Your ref
M/32/26/PL

Our ref
DSA000054905

Proposal: Demolition of the existing dwelling and garage and erection of 1 No. replacement self-build dwelling. This application is in CIL Zone 4 and is CIL Liable as a new dwelling.
Site: 60 Sea Way, Middleton-on-sea, PO22 7SA.

PL- Consultation- Southern Water response

Map Title: SW Print

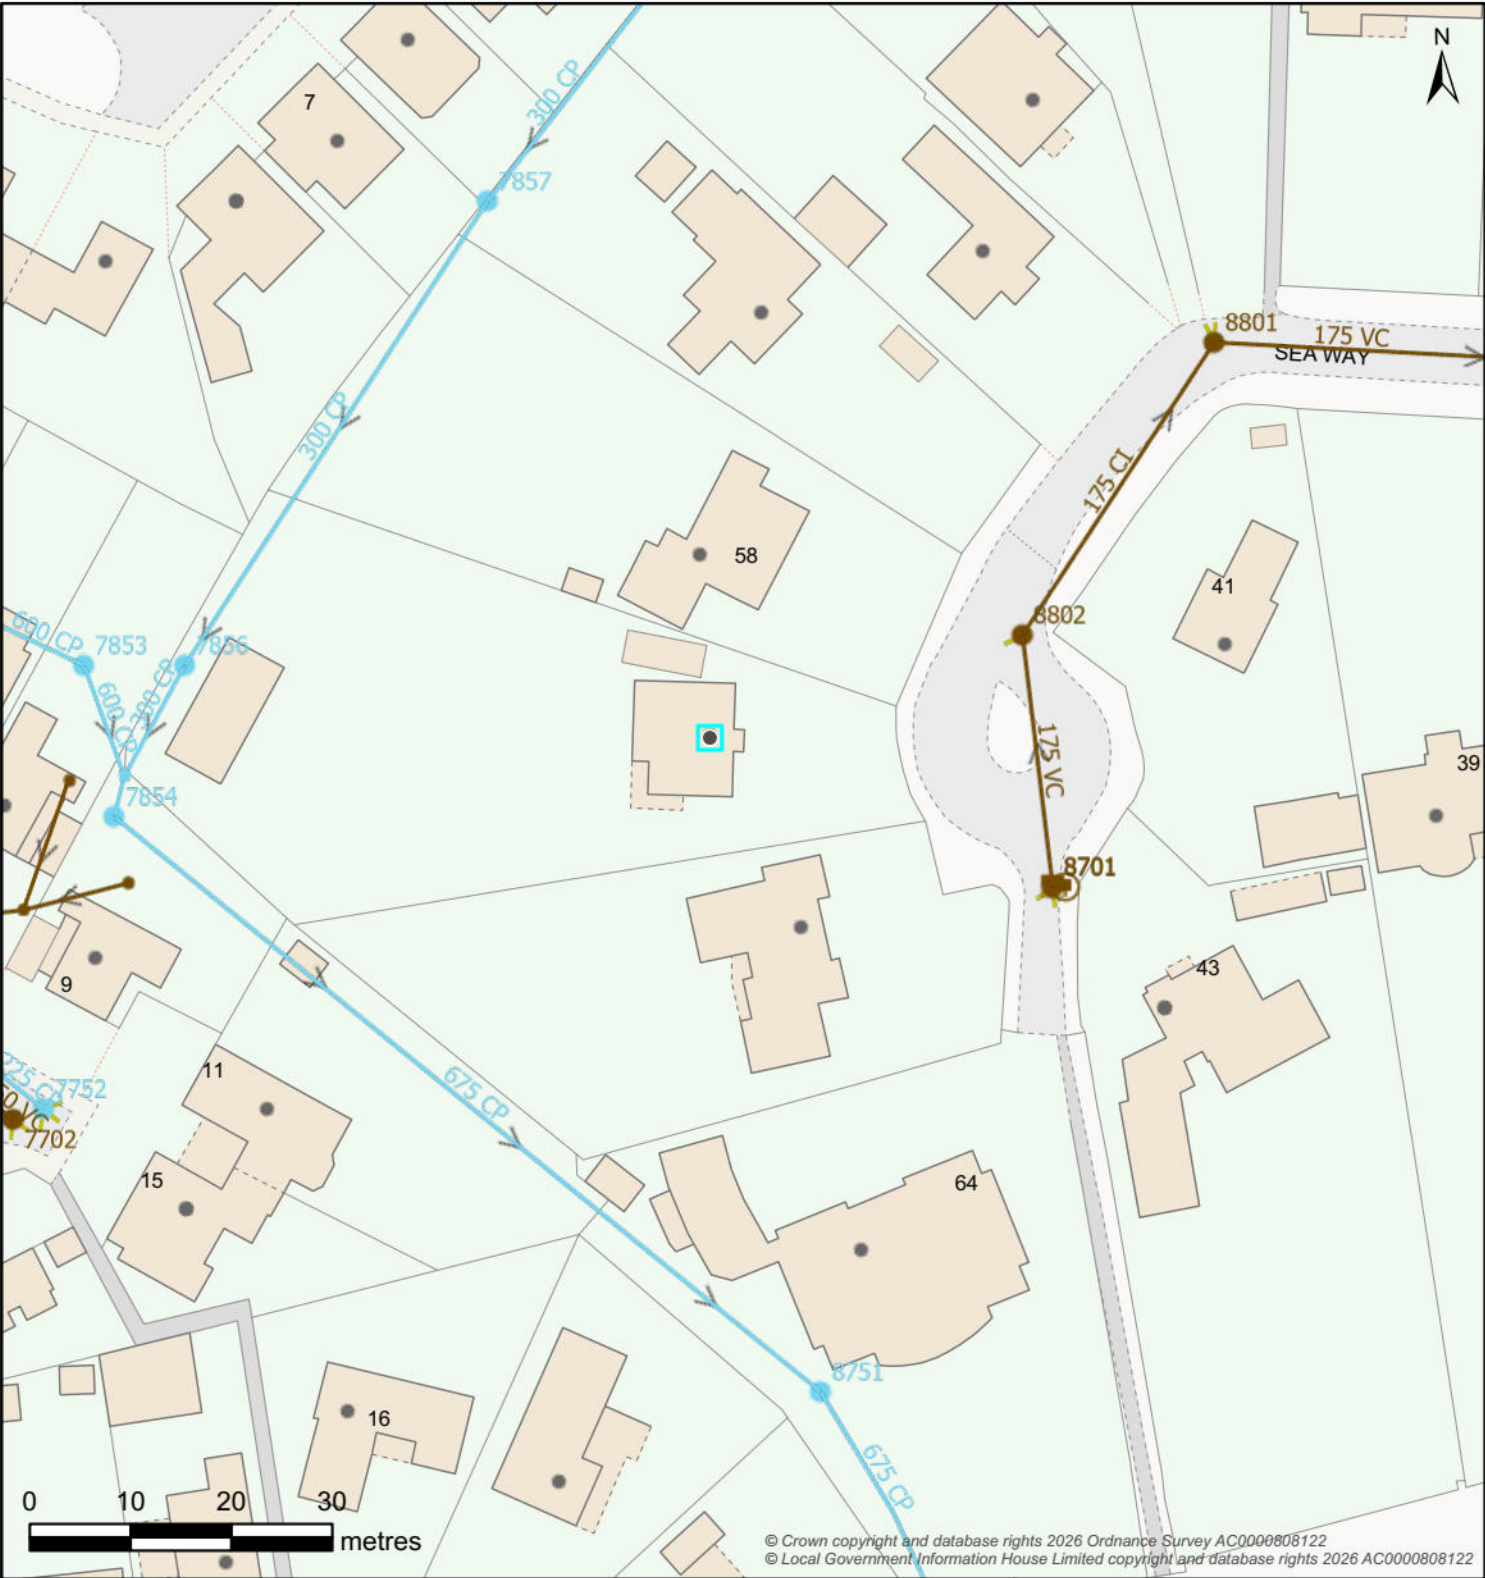
There is currently adequate capacity in the local surface water network to accommodate a surface water flow of 2.0 l/s for the above development at manhole reference SZ96997856.

It is possible that a sewer now deemed to be public could be crossing the development site. Therefore, should any sewer be found during construction work, an investigation of the sewer will be required to ascertain its ownership before any work commences on site. If this happens, please call our Customer Service Desk on [REDACTED]
